Re/genT Note¹:15424 / CE16 / V1		Technical Note
Project	Ecodesign & Labelling Review Household Refrigeration, preparatory/review study	
Subject	CECED Comments to Interim report (14.11.2015) Topic: Design options and LCC (chapter 12)	
Date	11-12-2015	
Author	Martien Janssen of Re/genT BV Lage Dijk 22 5705 BZ Helmond The Netherlands martien.janssen@re-gent.nl	
To	CECED WG Cold and Review study team

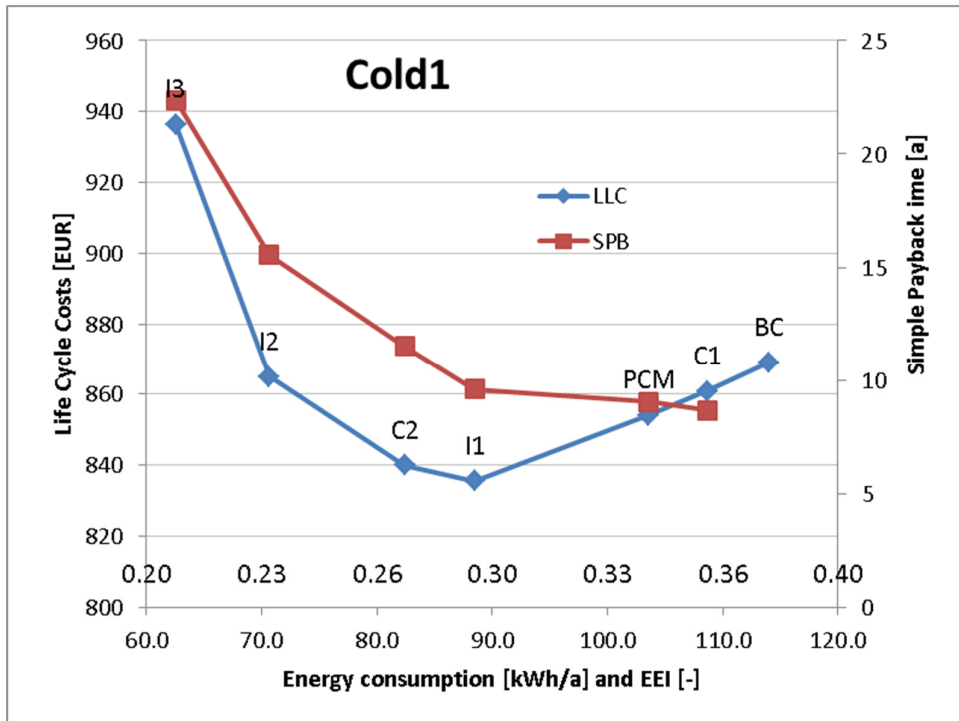
1. Option C3 uses a compressor of 1.98 nominal COP. Such compressor is only available at higher capacities, of interest to note is that due to this the energy saving with this compressor is smaller than with the lower efficient compressor C2, which is a realistic effect.

2. Option VSD is penalised by the lower COP value at the nominal capacity of 31 W. Again, this is realistic.
3. The insulation options are carried out with constant appliance volume by adding to height, width and depth the extra wall thickness of the foam. This is a correct approach for the analysis, though difficult to realise in praxis. Option I3 can be seen as “over insulated” as the thickness is very close to the optimal wall thickness for this product (85 mm).

4. Table 47 column Cold1 is not identical to table 49 column Cold1. The mistake is in the heat load calculation in table 47. Table 49 is further used as reference.

3. LLCC of Category 1

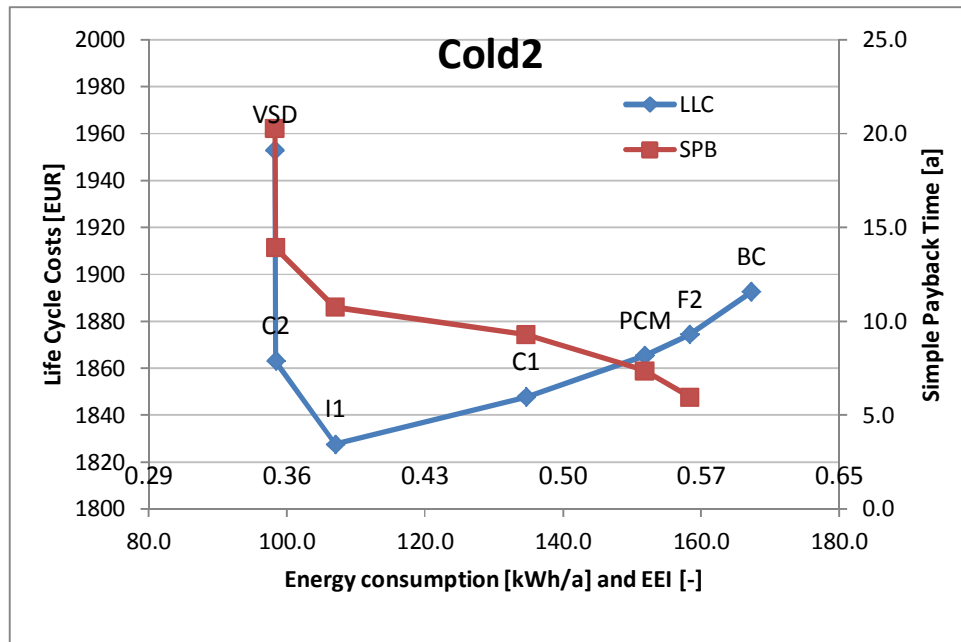
The calculations have been repeated with a slightly different order of options than in the report leading to the following chart:

The final conclusion is not very different from the one in the report, the minimum value (LLCC) is around 830 EUR resulting in an index around 0.3 and a saving of app. 25 % in energy. Note that payback times are quite high.

5. LLCC of Category 7

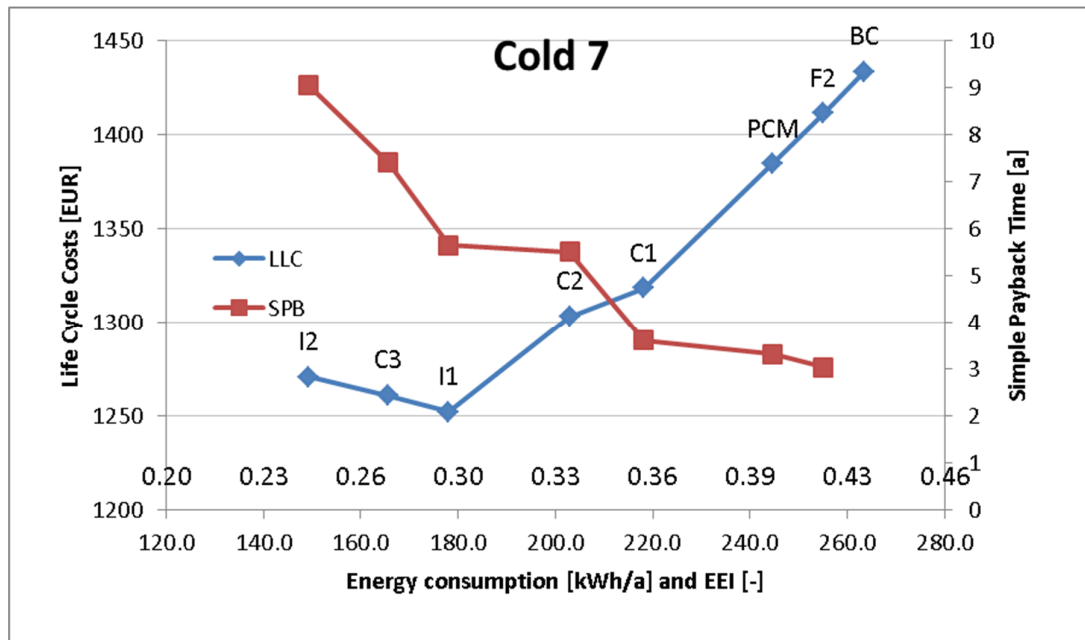
The calculations were repeated using the modified model for the combi described in Re/genT note 15423 / CE15 / V2. Note that due to this model change the base case product increased in consumption from 237 kWh/a to 263 kWh/a (or in terms of EEI from 0.39 to 0.42). This led to the following results:

The minimum LCC is found here at an EEI of approximately 0.3 whereas the report finds the minimum around 0.23. This difference is partly caused by the difference in the model, but also for a part due to a possible mistake in the EEI calculation in the report. The energy saving is app. 32 %.

6. LLCC of Category 8

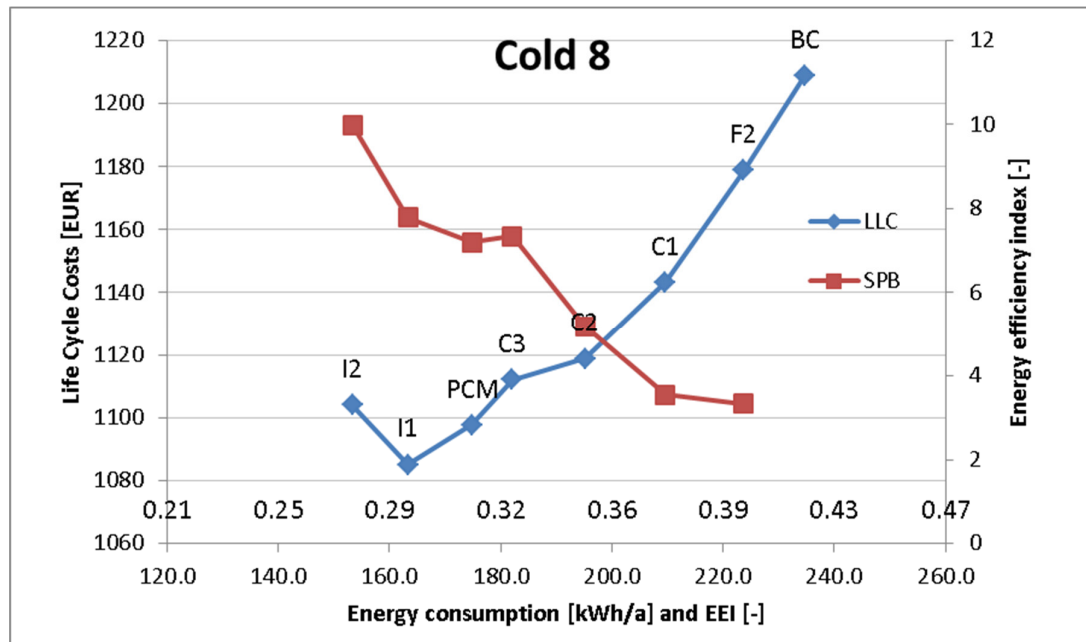
The calculations have been repeated with a slightly different order of options (excluding F1) than in the report leading to the following chart:

The final conclusion is different from the one in the report where the minimum value (LLCC) is around 1050 EUR at an index of 0.23 while here the minimum is 1085 EUR at index 0.29 with a saving of 30 % in energy.
